Product / Process Change Notification (PCN)

PCN Number: PCN_IndCMBNiZn_20240503

Affected Series: WE-CMB NiZn

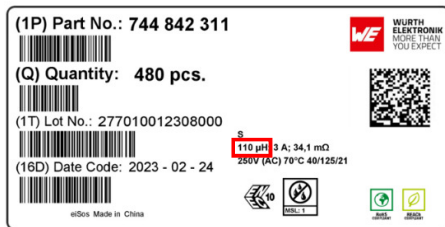
The international standard IEC 60938-2 is now requiring to print the inductance tolerance on the packaging label:

The current label doesn't show any inductance tolerance

The inductance value will be shown with tolerance
